UNITED STATES PATENT AND TRADEMARK OFFICE

APPLICATION NO.	FILING DATE	FIRST NAMED INVENTOR	ATTORNEY DOCKET NO.	CONFIRMATION NO.
10/599,917	07/25/2007	David Moorhouse	P01487-US-00 (13030.0013)	6580
22446	7590	05/12/2010	EXAMINER	
ICE MILLER LLP ONE AMERICAN SQUARE, SUITE 3100 INDIANAPOLIS, IN 46282-0200			EDEL, JOSEPH F	
			ART UNIT	PAPER NUMBER
			3636	
			MAIL DATE	DELIVERY MODE
			05/12/2010	PAPER

Office Action Summary	Application No. 10/599,917	Applicant(s) MOORHOUSE ET AL.	
	Examiner JOSEPH F. EDELL	Art Unit 3636

DETAILED ACTION

Diagram A - Annotated Figure 27 of Brightbill et al.

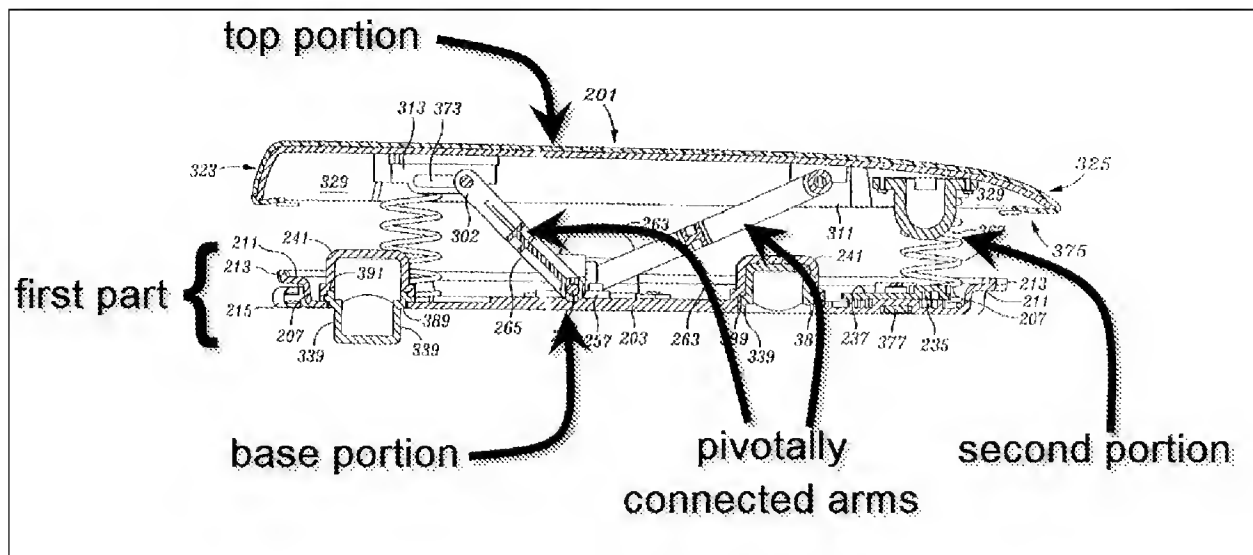
Brightbill et al. discloses a suspension system for a vehicle seat having a top portion (see Diagram A below), a first part with a base portion and means to receive top portion and to allow movement of the base portion and top portion towards and away from each other, a second part with an air spring adapted in use to control movement of the base portion and top portion toward and away from each other, at least one pair of pivotally connecting arms securing to each other the top and base portions, a first arm in each pair with one end pivotally secured to the base portion and a second arm in each pair releasably pivotally secured to the top portion, one or more bars 259,281,301 designed to extend from the base portion and receive the top portion and pivotally secured directly between the top and base portions wherein the top portion and second portion are releasably connected to the first part, the top and base portions are each respectively provided with upper and lower surfaces, the free end of each second arm is provided with means to allow it to move relative to an upper surface of the base portion, the free end of each first arm is provided with means to allow it to move relative to a lower surface of the top portion, the air spring is positioned between the base portion

and one of the first and second arms to control movement of the arms relative to the base portion, the air spring is positioned on or between two suitable mountings positioned between the first or second arms, the top portion is generally rectangular with short and long sides, the top portion is provided with one portion adapted to be releasably secured to each second arm of the first part, and the means to receive the free end of the first arm includes channels. See column 17, lines 24-40 of Brightbill et al. for the teaching that the spring elements may be two or more interchangeable parts.

means to allow movement of the base portion and top portion towards and away from each other” because support 32 remains stationary. Examiner disagrees. Brightbill et al.’s Figure 27 clearly shows the disputed claim limitations, and are pointed out in Diagram A above, where the base portion has a base 203 capable of receiving downward projecting components of the top portion and where the pivotally connected arms and second portion allow for movement of the base and top portions towards and away from each other. Reference numeral 32, which should have been numeral 323, is removed from the Office action to lessen any chance for ambiguity in the rejection of claims 1-9, 12-18, 52, and 53.
